57 Cutler Rd Clontarf

Lot 30 Sec DP 25654

Modification to Development Consent
mod 2024/0570

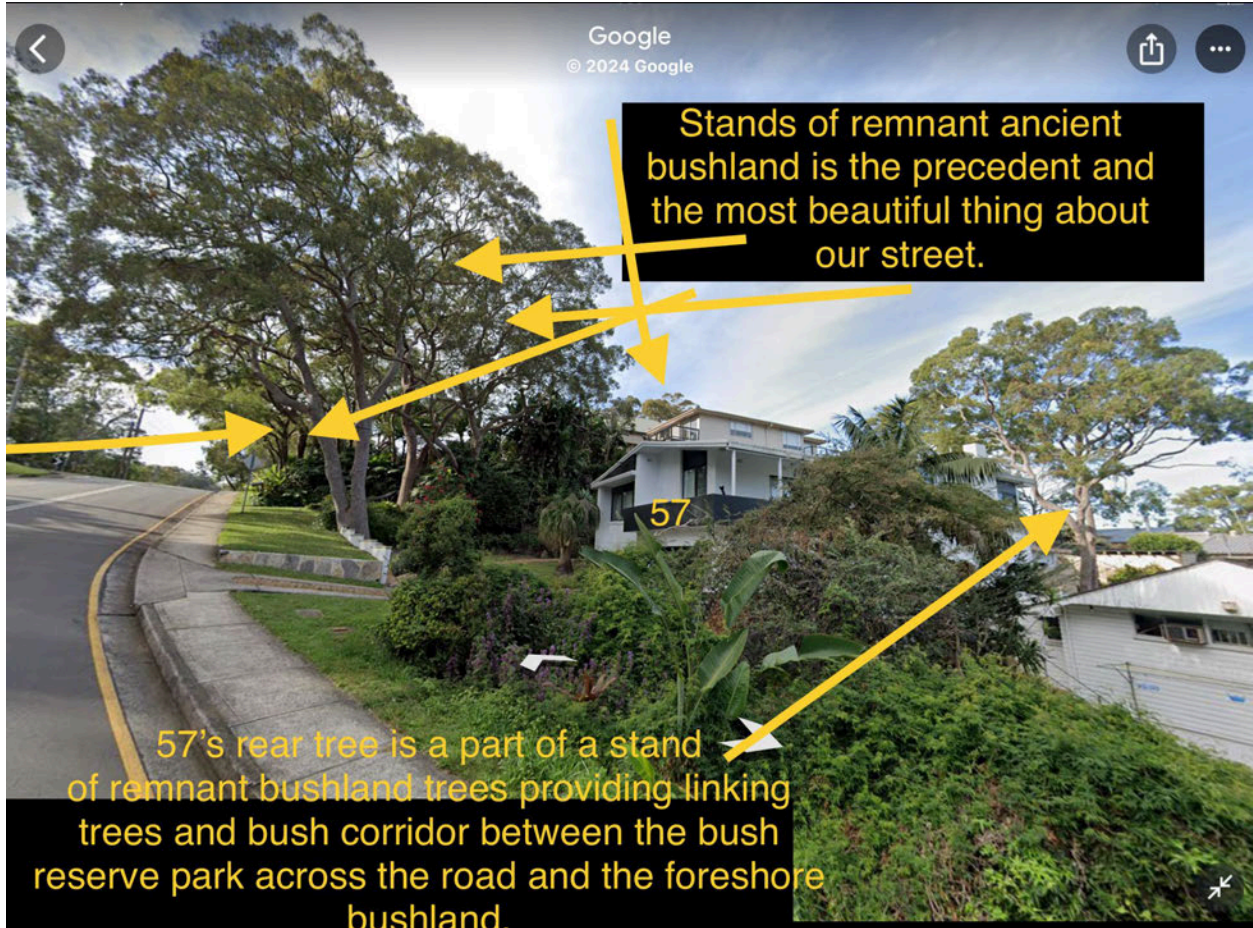
Below is a picture of 57's rear tree viewed from my living room window facing West. The current rear setback roofline has allowed this view sharing for 70 years.

Many of these birds are territorial and have a small territory. Therefore this tree is critical to their well-being and it is a protected species, mature and an important bush corridor habitat tree. The beauty of 57's beautiful mature tree filled with wildlife is awe inspiring on a daily basis and one of the very best things about living here. It is priceless and cannot be replaced. I want to continue to see nature and continue to experience the cooling effect of 57's rear lawn and the lovely shade from the 57's rear tree. The mature native Angophora Costata is a protected species and designated by 57's Raintree Arborist to be retained and protected in perfect condition.

55 Cutler Rd

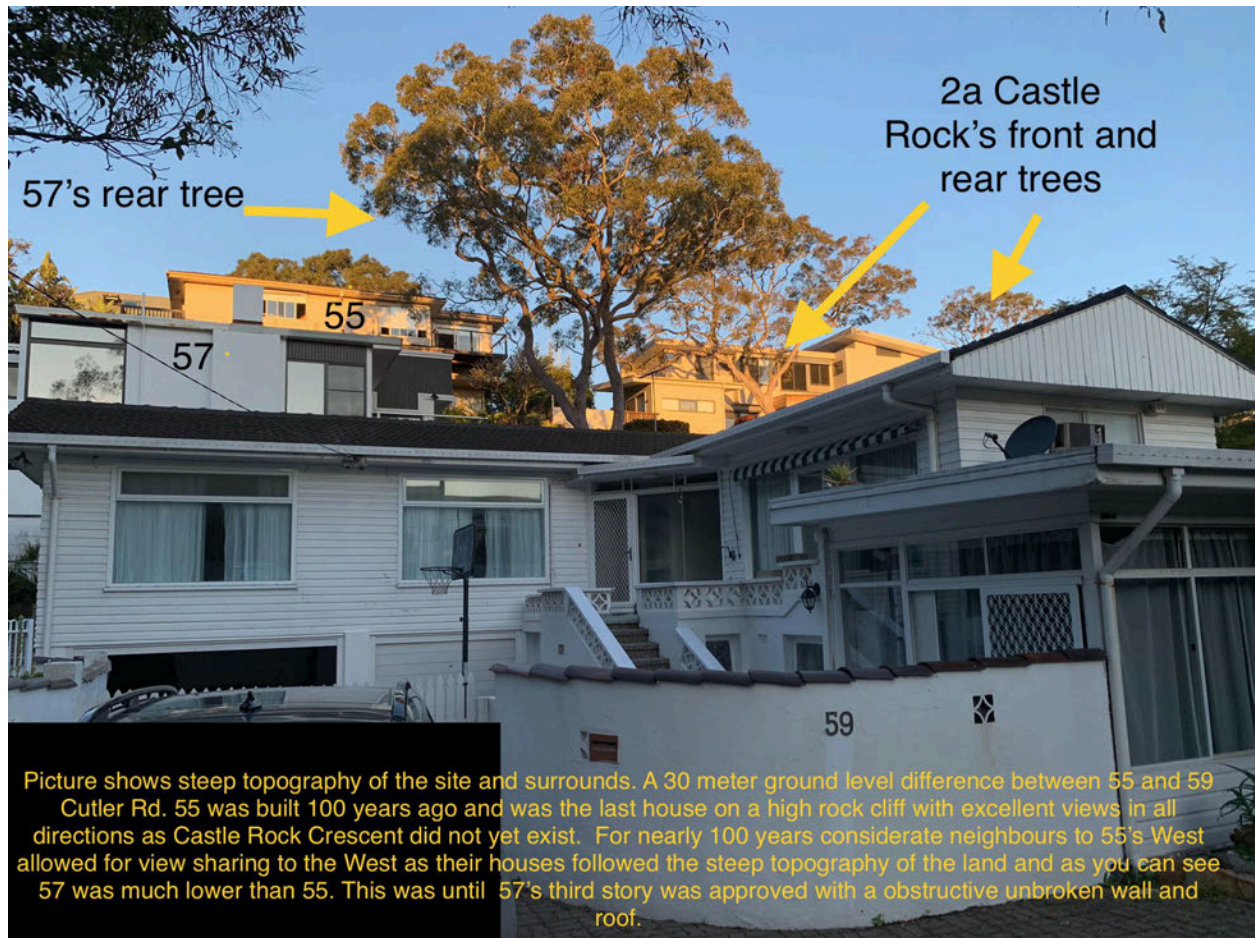
Numerous properties have trees beside their buildings within this area. 57's arguments do not follow the existing precedent.

Below. As it is currently with 2 -3 meters deep of fill removed around rear tree

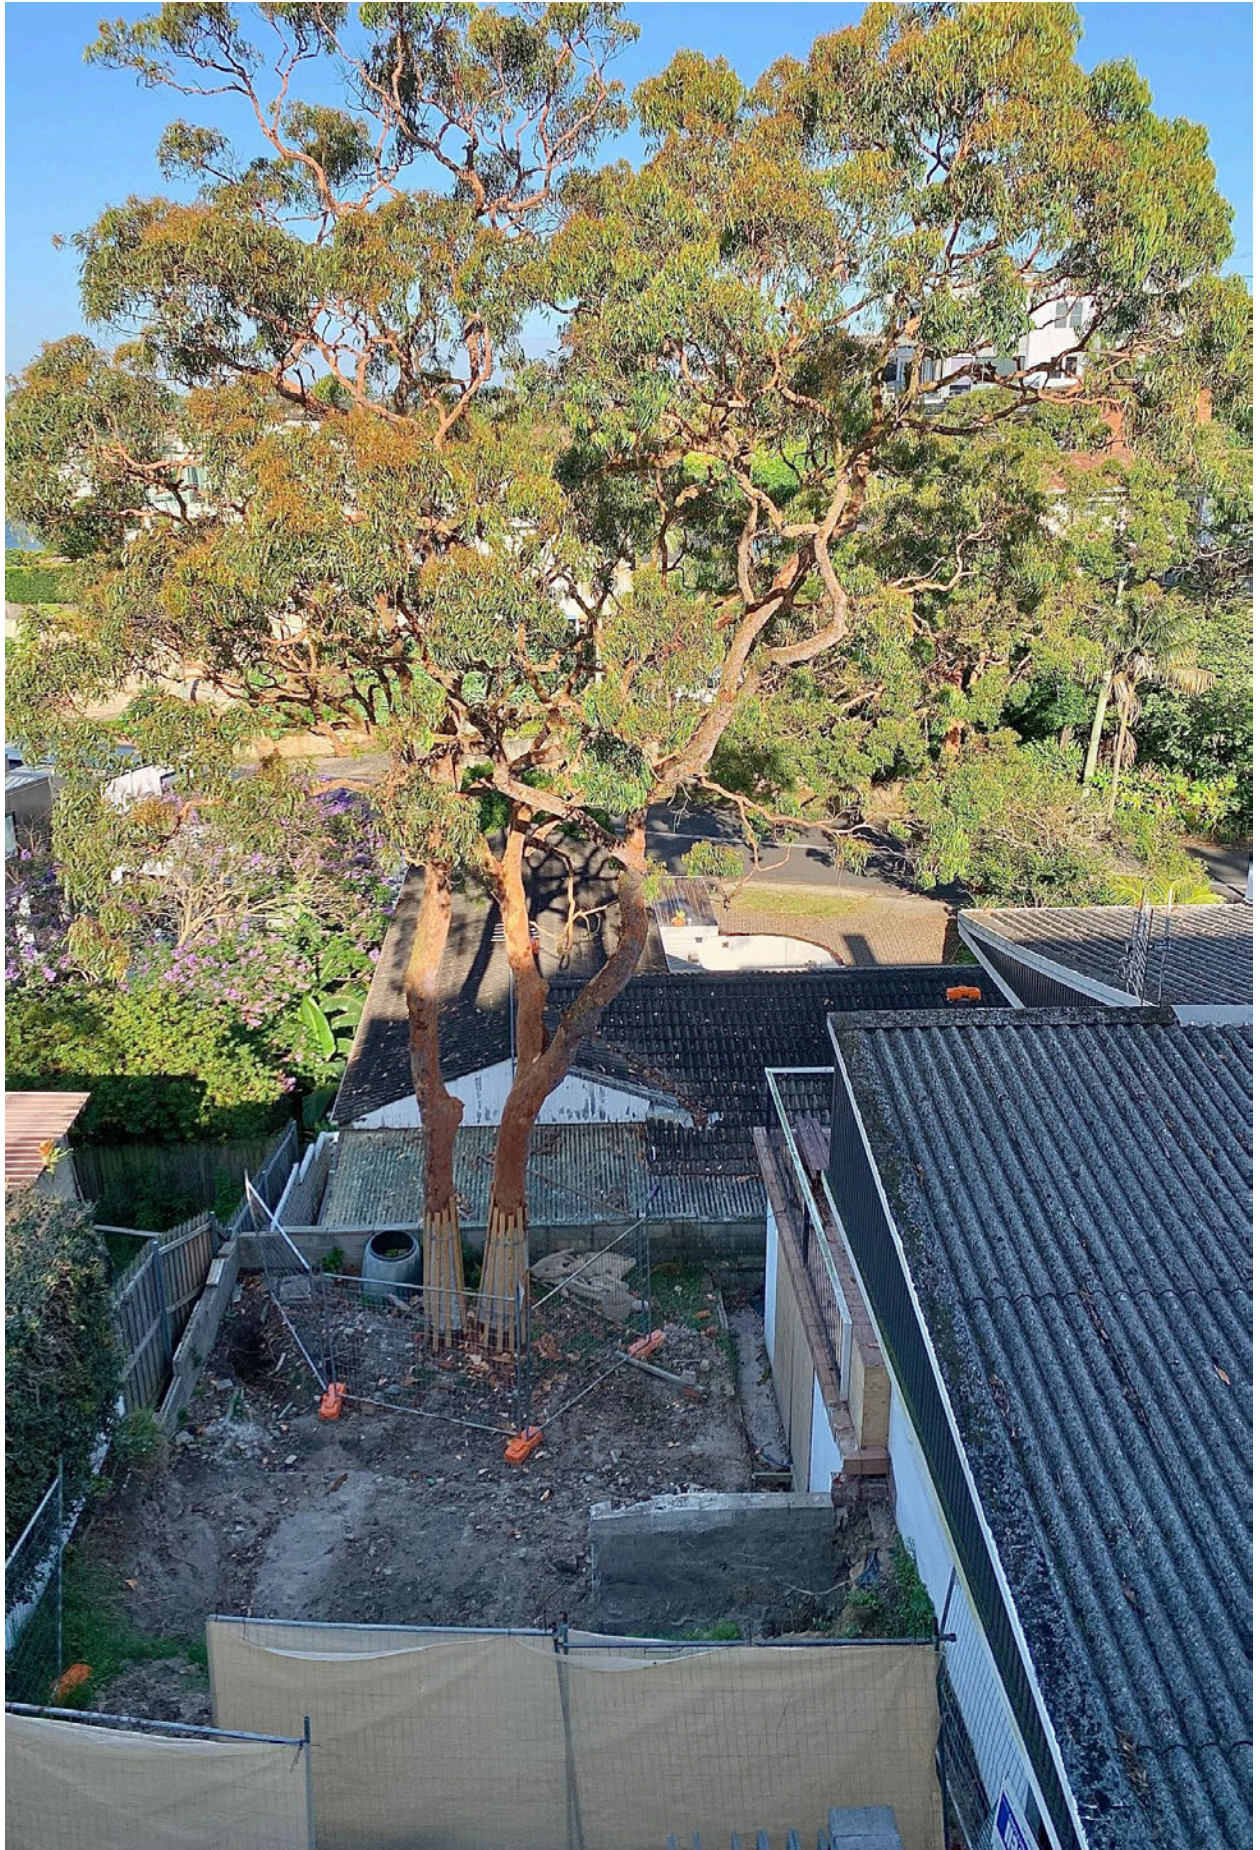
A refusal to redirect sewerage should not be entertained at the expense of a protected tree.
